APPEAL SUMMARY

Appeal ID: 21940	Project Address: 200 NW Royal Blvd, Lot #2
Hearing Date: 10/2/19	Appellant Name: Robert Oshatz
Case No.: B-003	Appellant Phone: 5036354243
Appeal Type: Building	Plans Examiner/Inspector: Jill Grenda, Nancy Thorington, Stacey Castleberry, Eric Engstrom
Project Type: residential	Stories: 3 Occupancy: R Construction Type: V-B
Building/Business Name: RHO LLC	Fire Sprinklers: No
Appeal Involves: Reconsideration of appeal	LUR or Permit Application No.: 06-109711-LU
Plan Submitted Option: pdf [File 1] [File 2] [File 3] [File 4] [File 5]	Proposed use: Single family residence

APPEAL INFORMATION SHEET

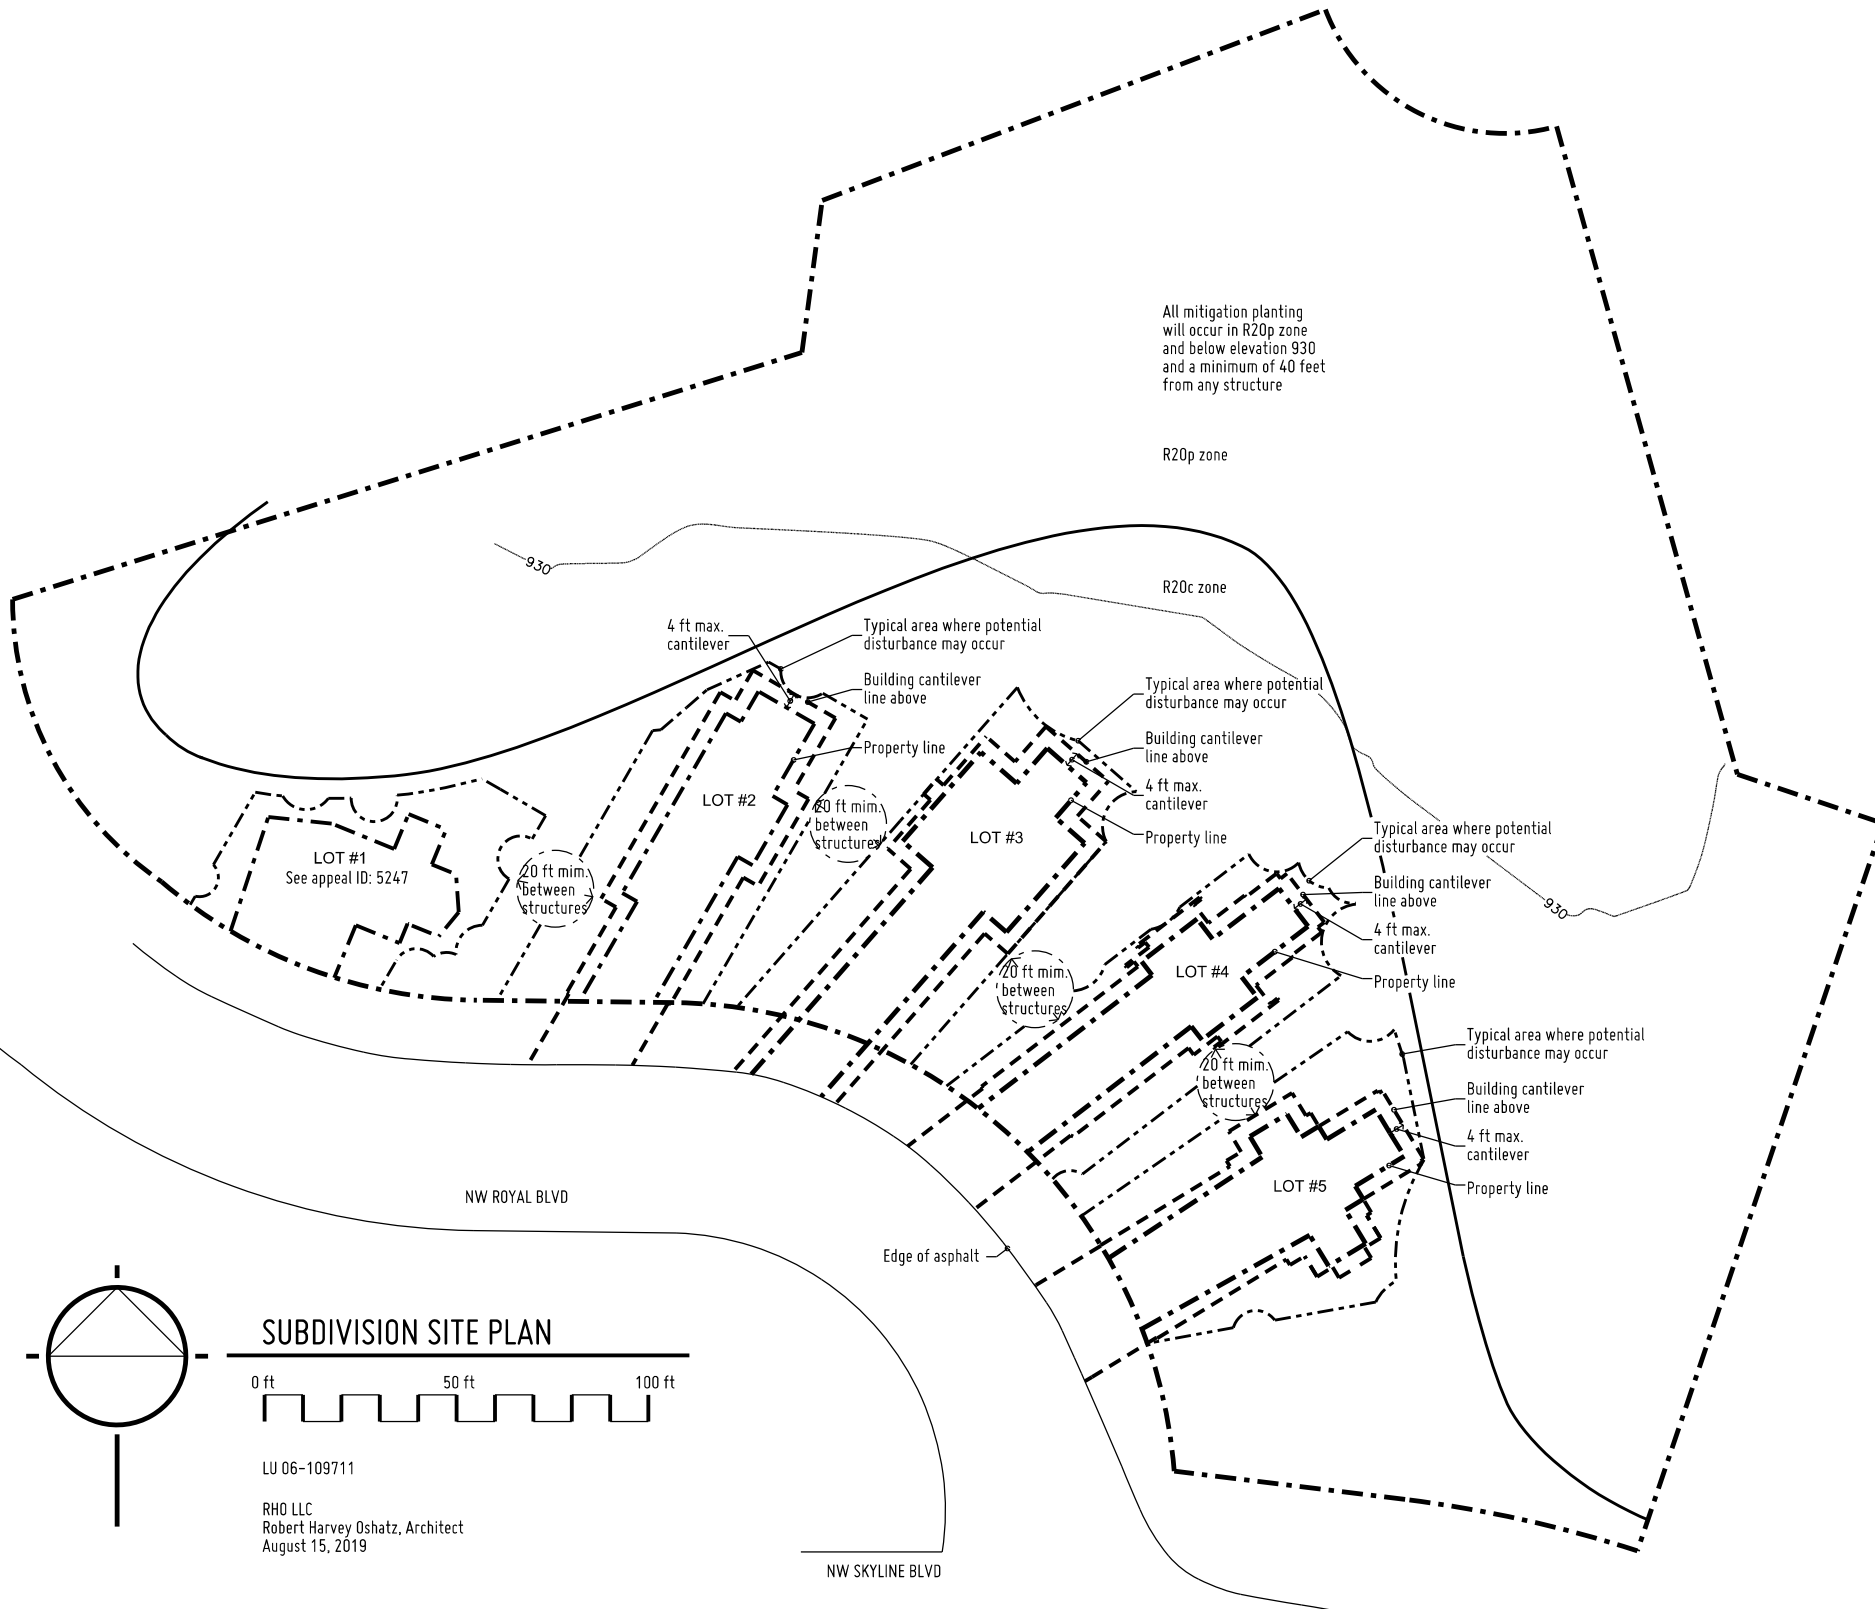
Section R302.1 of the 2005 Oregon Residential Specialty Code is concerned with public safety. It requires that openings are not permitted less than 3 feet from a property line. Essentially this results in a separation of openings between structures of at least 6 feet to prevent fire spreading. In this appeal, for Lot #2 will be at least 20 feet away from any future structure on Lot #1 and Lot #3 (as required by the subdivision approval). This is greatly exceeding the 6 feet suggested by R302.1. Thus, the design follows the intent of the code and more than satisfies it.

I feel code guide OSSC/32/#1 should not apply in this case. In the past it has been targeted for cantilevering into public common areas that is used by the public. This is a case where the structure is cantilevering into its own privately not open to the public green space. When the subdivision is look at with its private common green space (which is not open to use by the public and since the site is steeply sloping and the structures are not design for their occupants to use the private common green space) in essence the house is meeting the concerns of a residence built in a R20 zone. In reality except to meet zoning requirements of an environmentally sensitive site the property lines are imaginary (in essence the planning department is saying this by going along with the concept of cantilevering over the property lines and requiring the residence to be a minimum of 2,000 sf).

Openings in exterior walls at property line: Granted as proposed.

The Administrative Appeal Board finds that the information submitted by the appellant demonstrates that the approved modifications or alternate methods are consistent with the intent of the code; do not lessen health, safety, accessibility, life, fire safety or structural requirements; and that special conditions unique to this project make strict application of those code sections impractical.

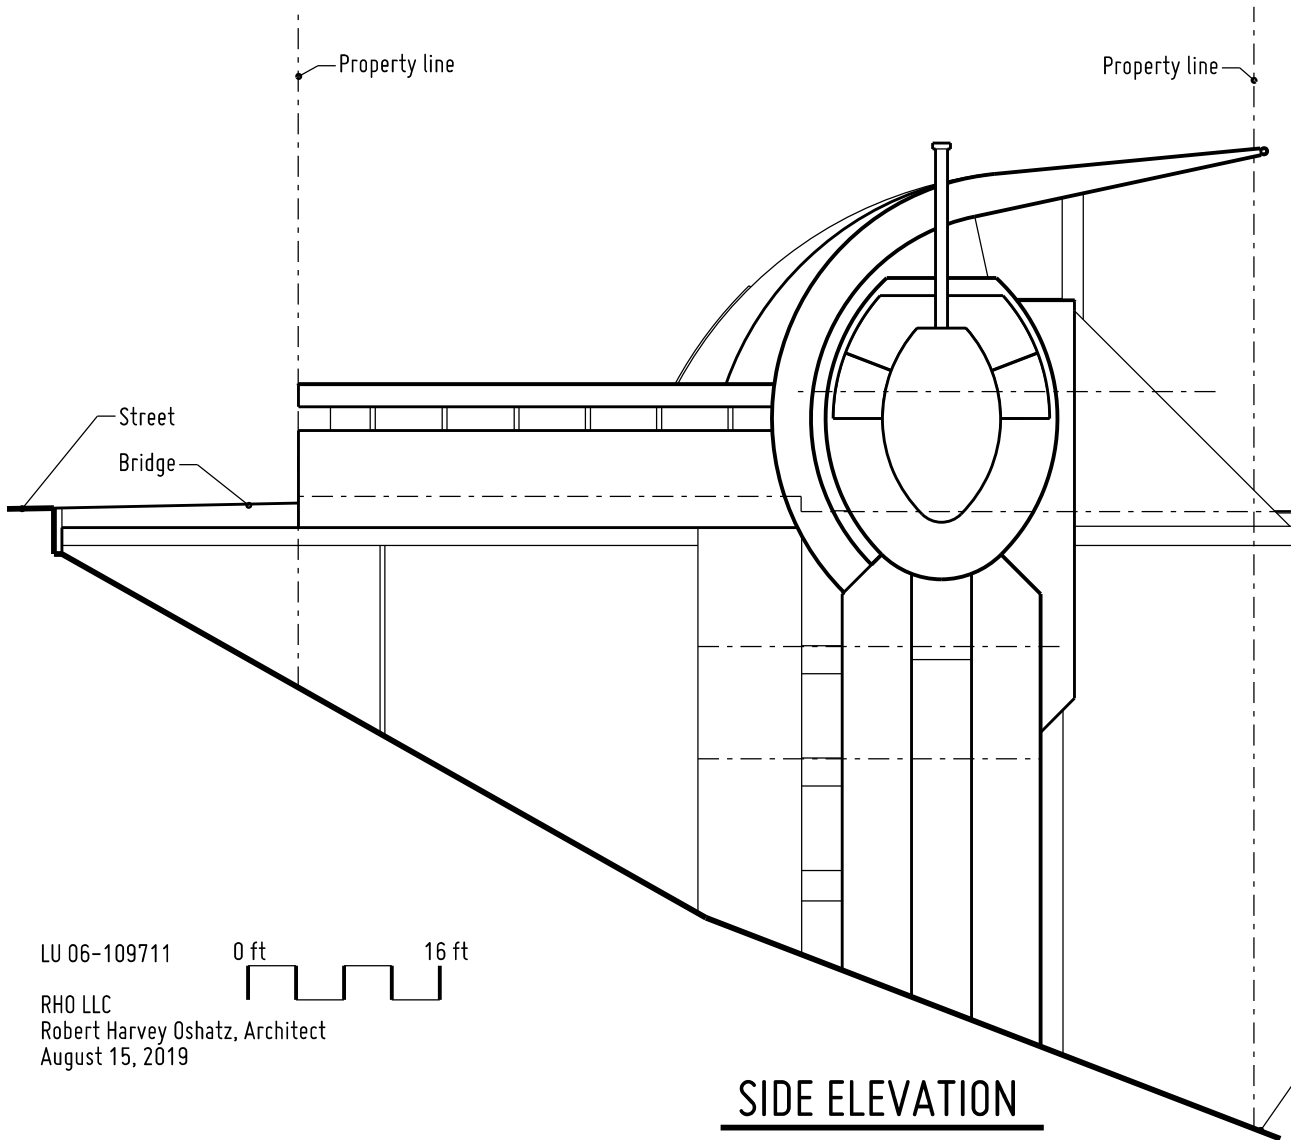
The cantilever deck which will be constructed of steel beams, 4x14 joist and 2x6 outdoor decking; the roof will be Class B materials, the walls are cad in sheet-metal, wood and stucco and soffits will be 5/8" fire rated gypsum board; making the structure at least as safe as any other residence in the neighbor. In addition, I am willing to work with the Fire Marshall's office to mitigate any of their concerns.
